US-APWR DCD Revision 3 Tracking Report

December 2011

General Description

Figure 2.4.4-1 Emergency Core Cooling System (Sheet 4 of 4)

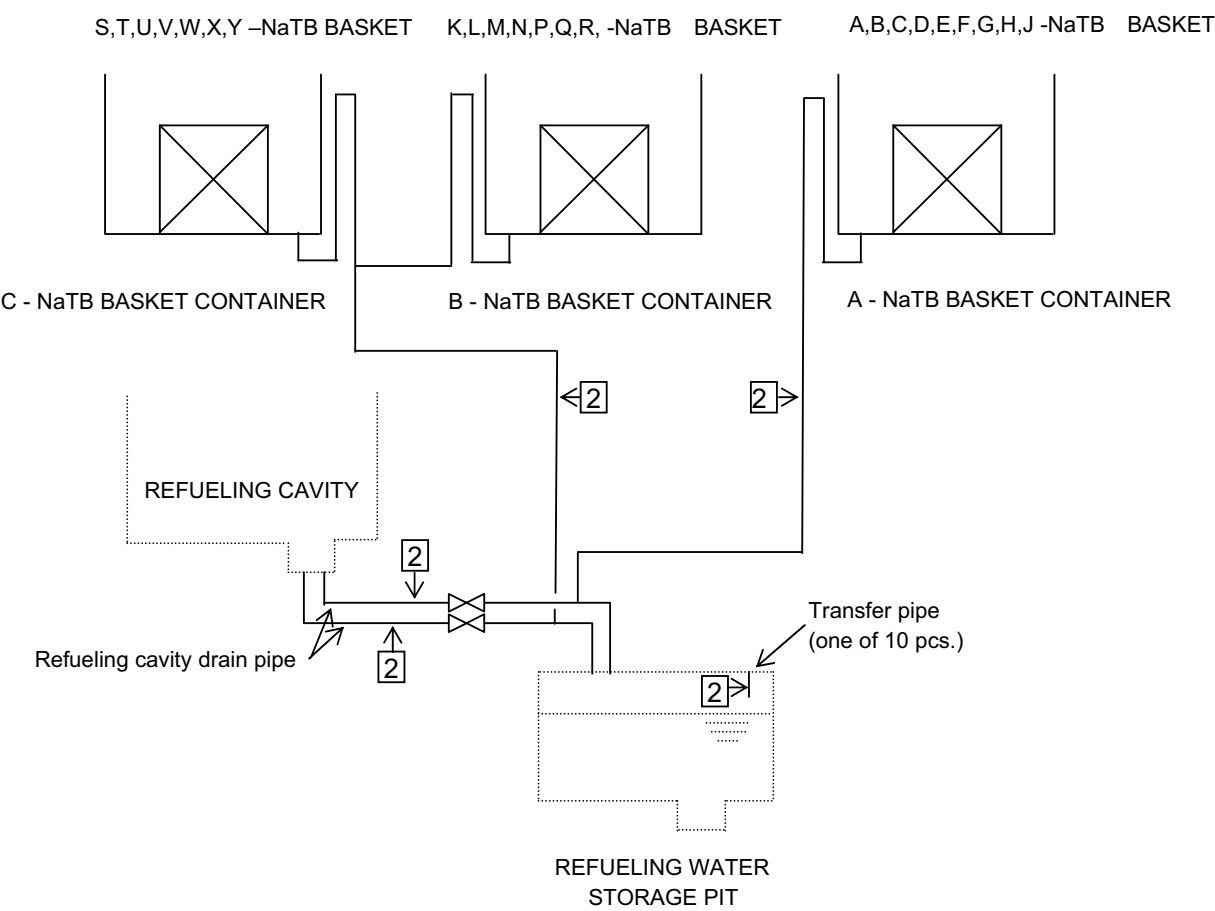
DCD_06.02.02-38	Tier 1 Figure 2.4.4-1	2.4-60 [2.4-59]	GSI-191, Response to	Add the wording, "(one of 10 pcs)."	1

Figure 2.5.6-1 DCS Configuration

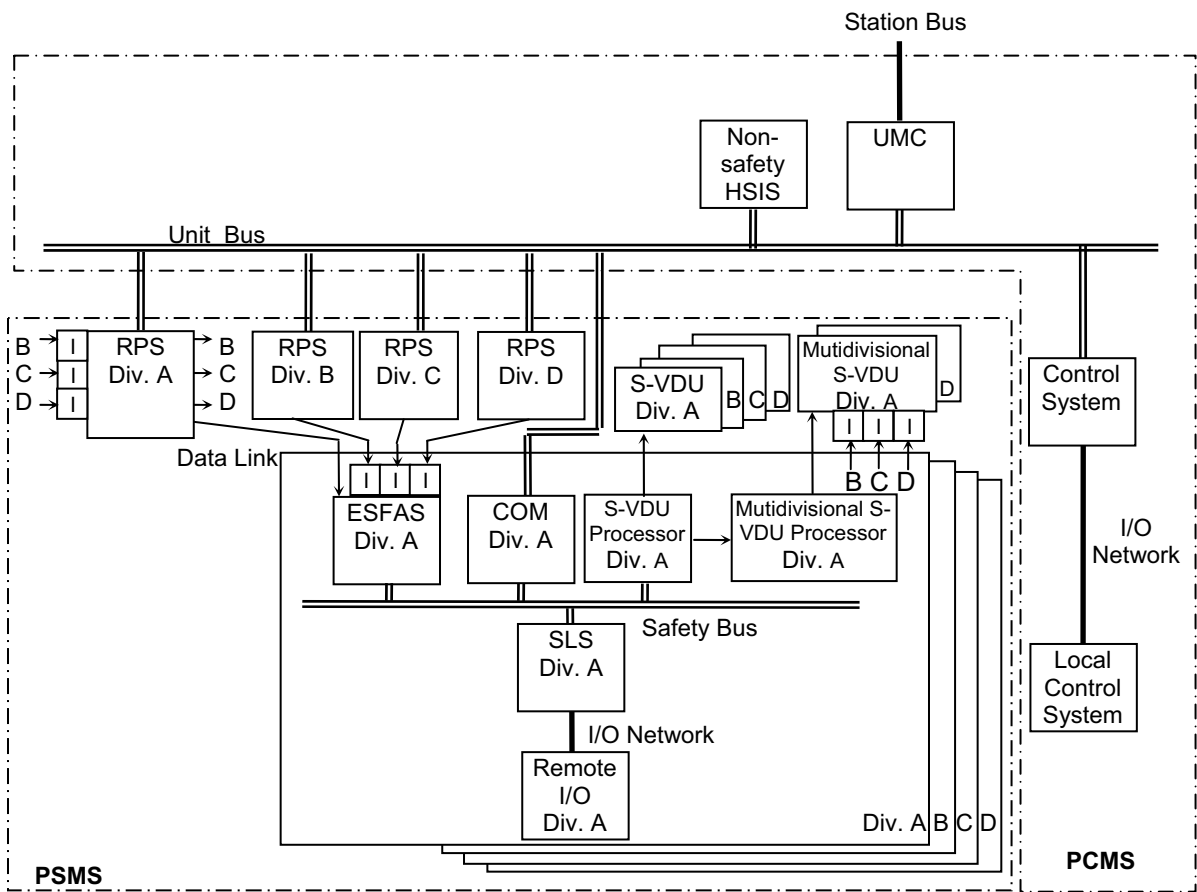
Change ID No.	Location (e.g., subsection, table, or figure)	DCD Rev.3 Page *	Reason for Change	Change Summary	Rev. of T/R**
	(Sheet 4 of 4)		RAI No. 354 MHI Letter No. UAP-HF-09365 Date 07/07/2009	(Clean-up item)	
MIC-03-T1-00002	2.5.1.1 Table 2.5.1-2 Table 2.5.1-3 Table 2.5.1-6 (sheet 10) 2.5.6.1 Table 2.5.6-1 (Sheet 1) Figure 2.5.6-1	2.5-1 2.5-4 2.5-6 2.5-7 2.5-8 2.5-9 2.5-19[2.5-20] 2.5-49 2.5-51 [2.5-52] 2.5-53 [2.5-54]	Response to RAI No. 771/778 MHI Letter No. UAP-HF-11244 Date 8/1/2011	Revised the 1st sentence of Section 2.5.1.1. Added the item 31 in Section 2.5.1.1. Added the column of "Response Time Requirement" in Table 2.5.1-2. Added the column of "Response Time Requirement" in Table 2.5.1-3. Added the item 31 in Table 2.5.1-6. Deleted item 2 in Section 2.5.6.1. Deleted item 2 in Section Table 2.5.6-1. Added "multidivisional S-VDU" in Figure 2.5.6-1.	1
